Report: TAB REPORT
Function: Test, Adjust, & Balance
Date: 08/19/2025
Completed By: National TAB

PROJECT
08-18-25 CAVA BURLINGTON, MA

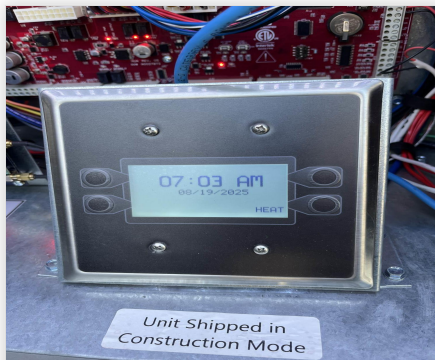
Issue Name : Hood Controls
Description : Supply motor not visible in hood controls. Appears configuration of hood setup is incorrect and needs review from Captive Aire tech. Adjusted MUA fan speed at unit by changing blower control to VFD Manual. Hood is also alarmed for CORE 1 fault. Switch is not on test but alarm remains, not impacting hood operation. Needs Service.
Created By : National TAB **Assigned To :** National TAB - Michael McDonnell
Status : Open
Priority : Medium **Asset Tag :**
Originated Date : 08/19/2025 - Michael McDonnell - National TAB

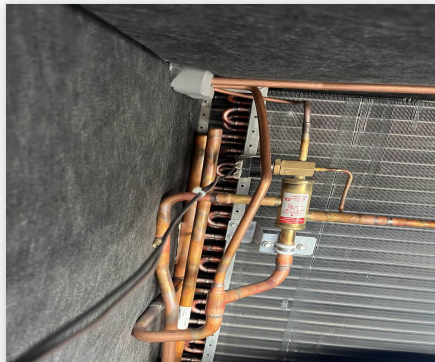
Issue Name : RTU Dehumidification
Description : RTU model numbers and reheat coil indicate units have dehumidification. No humidity sensors are installed or wired for either RTU. Recommend humidity sensors are installed so units can control space humidity.
Created By : National TAB **Assigned To :** National TAB - Brianna Biggs
Status : Open
Priority : High **Asset Tag :**
Originated Date : 08/19/2025 - Michael McDonnell - National TAB

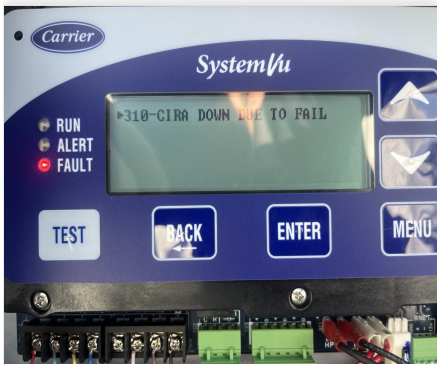
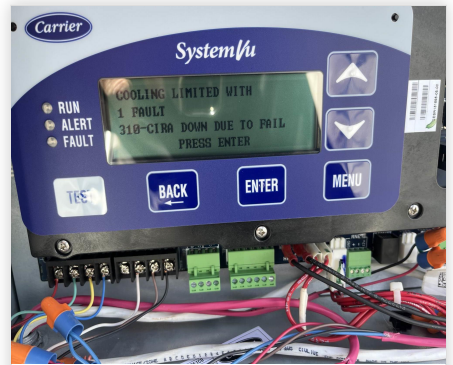
Issue Name : RTU-1 (KITCHEN): Cooling is not Functional
Description : Cooling is locked out on RTU-1 serving the kitchen. Suspect low pressure alarm. Unit needs service.
Created By : National TAB **Assigned To :** National TAB - Michael McDonnell
Status : Open
Priority : High **Asset Tag :**
Originated Date : 08/19/2025 - Michael McDonnell - National TAB

- **08/19/2025 National TAB - Michael McDonnell**
 - Gas valve at this unit in off position. Suggests unit has not been started up. Could not test heat.

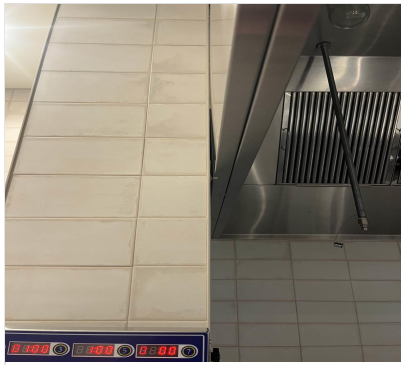
Gap on left side of wall. Will allow for accumulation of grease and dirt. Recommend this is sealed.
